Browns Summit Creek Restoration Project Year 1 Monitoring Report

DMS Project ID No. 96313, DEQ Contract No. 5792

Subject: Response to Task 7 Draft Year 1 Monitoring Report Comments dated January 2, 2018
Browns Summit Creek Mitigation Project, Guilford County
Cape Fear Cataloging Unit 03030002
USACE AID SAW 2014-01642, CMS Project #96313

Figure 7 Wetland Restoration Graphs (2017)

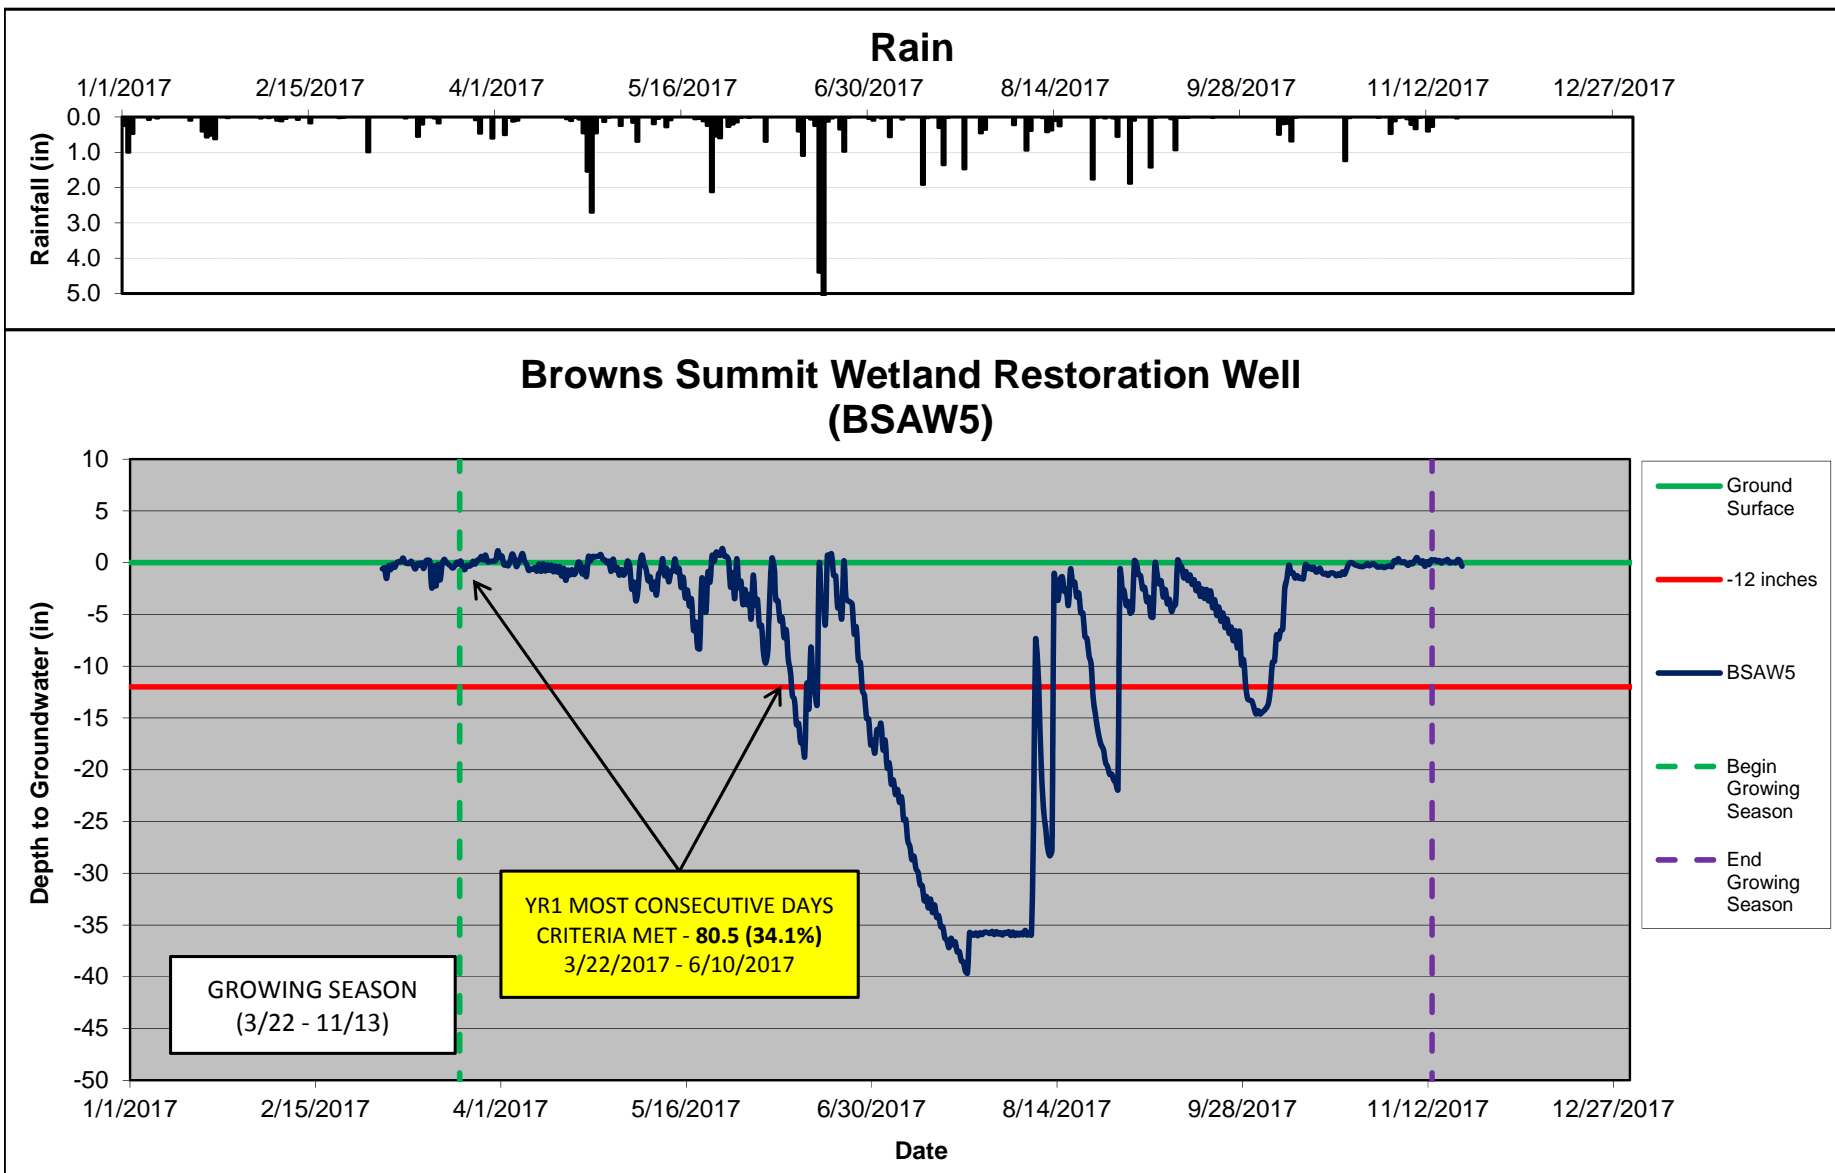
2. Section 1, page 2: Explain why there was a month gap in data for gauge BSAW2 during the monitoring period.

Response: The automated collector was not acquiring data properly, upon re-inspection approximately one month into the monitoring season, the logger was re-set and began acquiring data.
